Melton City Council Submission

Melton East Precinct Structure Plan and Infrastructure
Contributions Plan

Melton City Council

April 2025

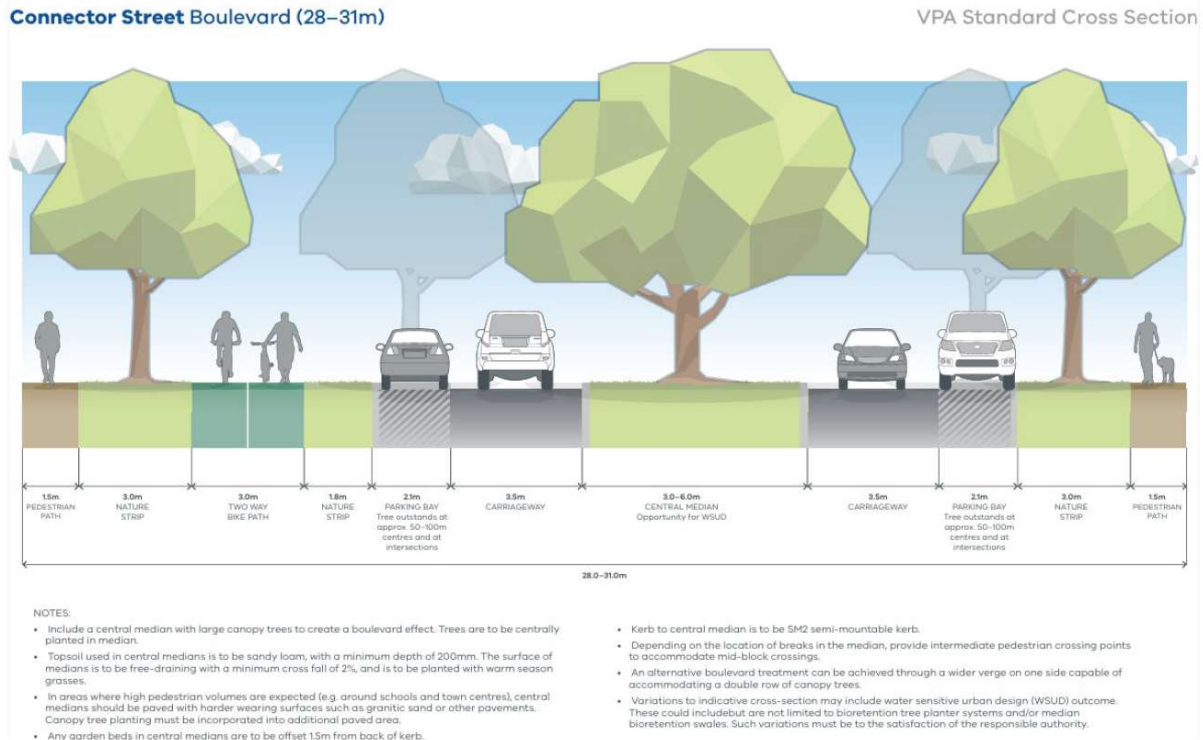
Council requests that the variation on the road reserve width for the connector street – boulevard should be removed and the PSP should nominate each road reserve width applies. Council officers would welcome the opportunity to work through the application in the PSP with the VPA to form an agreed position.

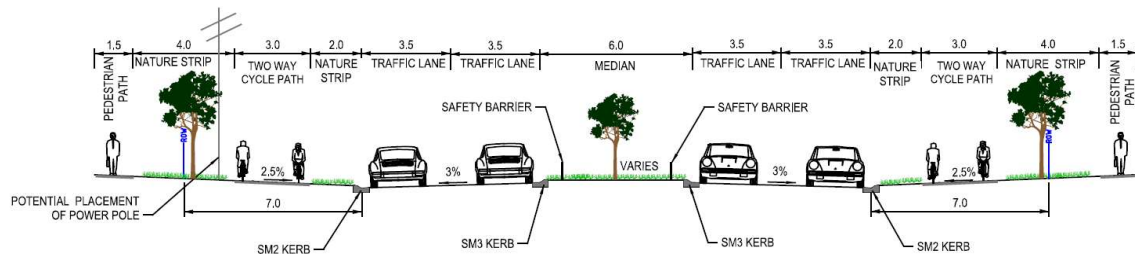
The cross sections in the PSP and ICP don't match. Council requests that relevant documents in the Amendment be amended to be consistent to ensure the correct infrastructure is built.

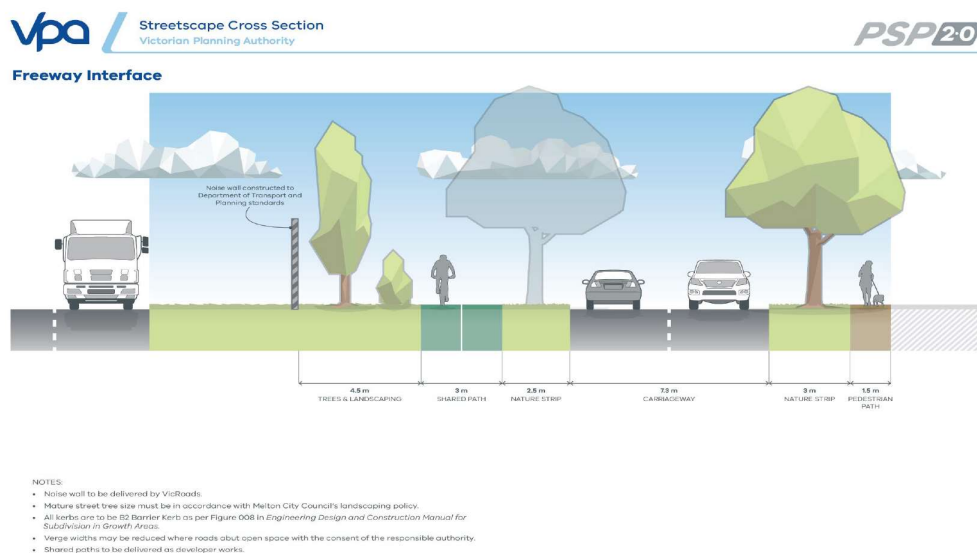
Council request that the PSP be changed to show / mark the extent of freeway in the Freeway Interface Road. Council requests that a shared path be shown as part of the interface road to facilitate delivery and ownership.

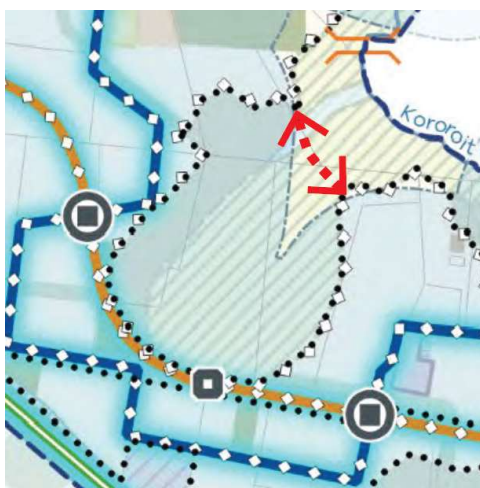
The West Corridor Growth Plan recognises this significance and identifies Kororoit Creek as part of the Metropolitan Trail Network (MTN). The Melton East PSP generally aligns with this intent by proposing an off-road shared path, however there is a notable gap in the proposed shared path along the creek in the vicinity of the regional open space and crossing Leakes Road (see plan extract below).

Council request that the PSP is changed to extend the proposed off-road shared path along Kororoit, generally as shown above.

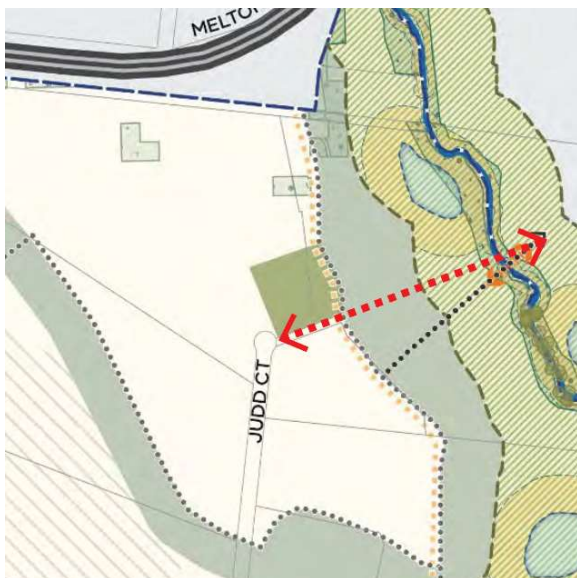
Taylor's (Beattys) Road shared path. The shared path proposed along the north side of Taylor's Road is discontinued from the eastern approach to the main conservation area. This would require pedestrians to cross the arterial road twice.

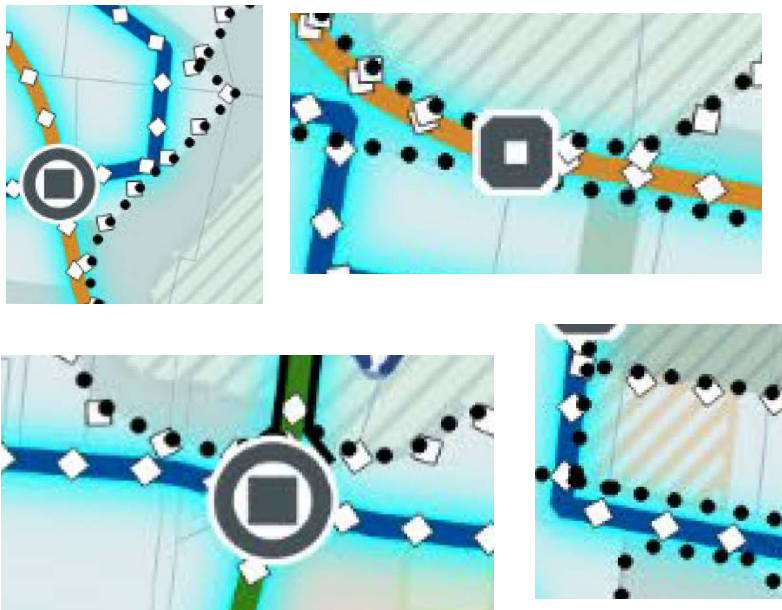
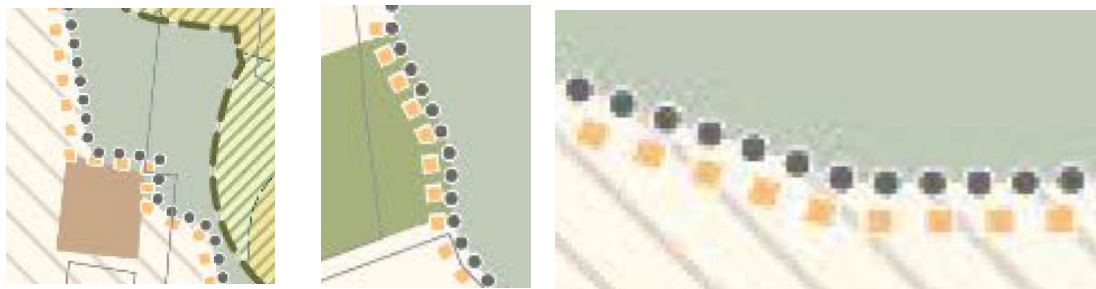
Council request that the PSP is amended to avoid duplicating paths. Some paths near conservation areas are close to road paths and can be combined as shown in the examples below.

Council requests that the PSP is amended to show a single path where possible, and avoid the duplication of paths as shown in the examples above.

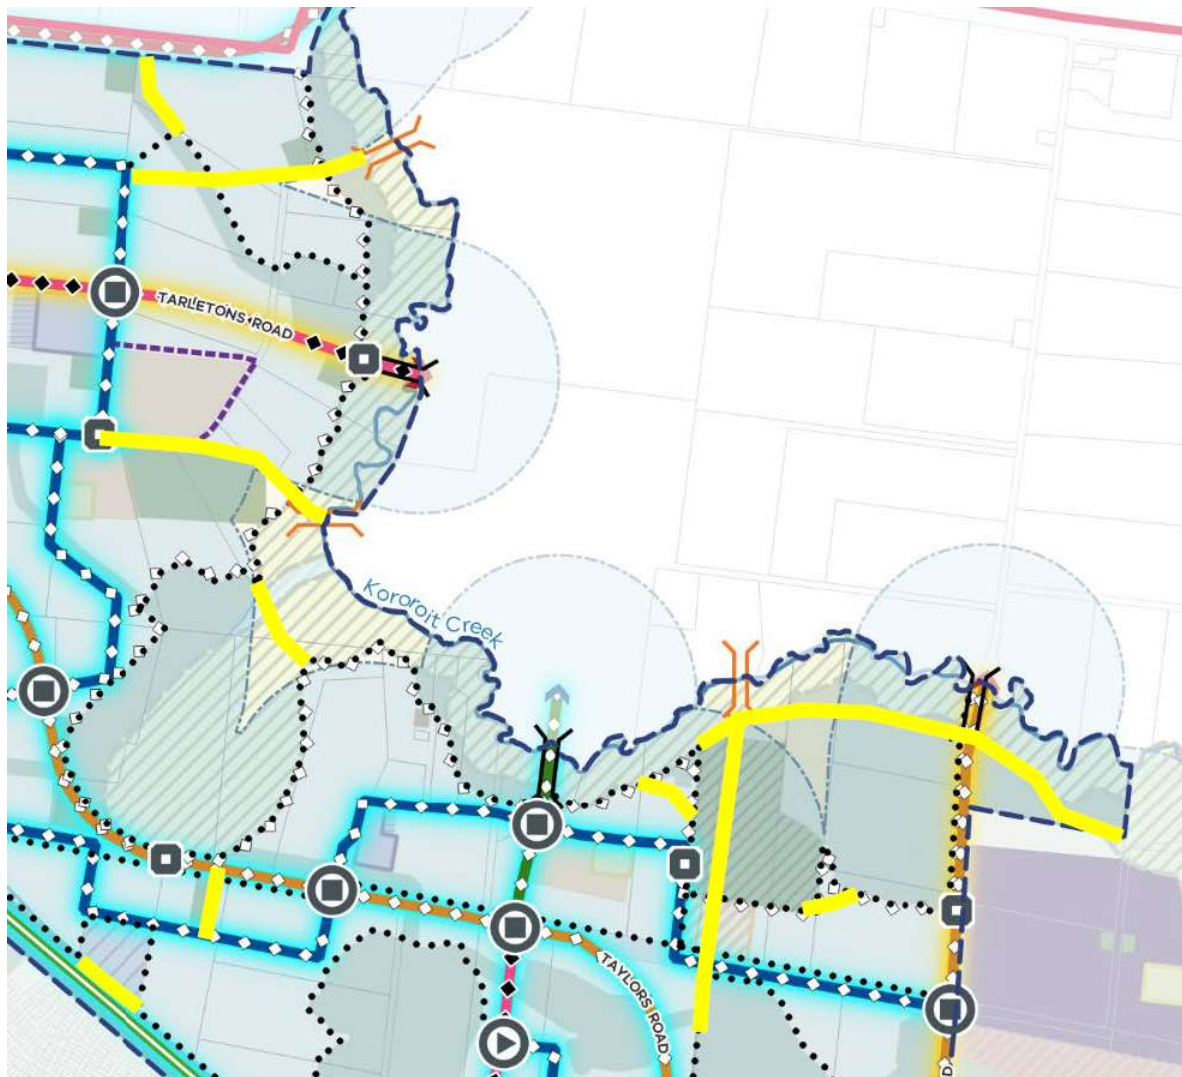
Council submits that there are several locations where paths are indirect for pedestrians and cyclists. Council submits that the PSP should be changed to show the additional/ realigned paths below to smooth out the journey.

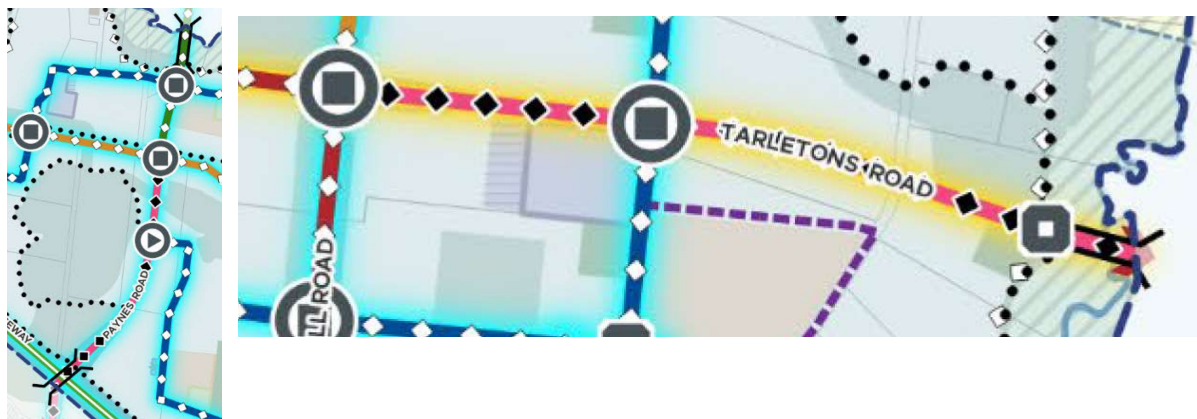
Council submits that separated footpaths and bike paths are preferred to shared paths and on-road bike lanes for secondary arterial roads (Paynes Road and Tarletons Road).

The paths can merge to shared paths over bridges
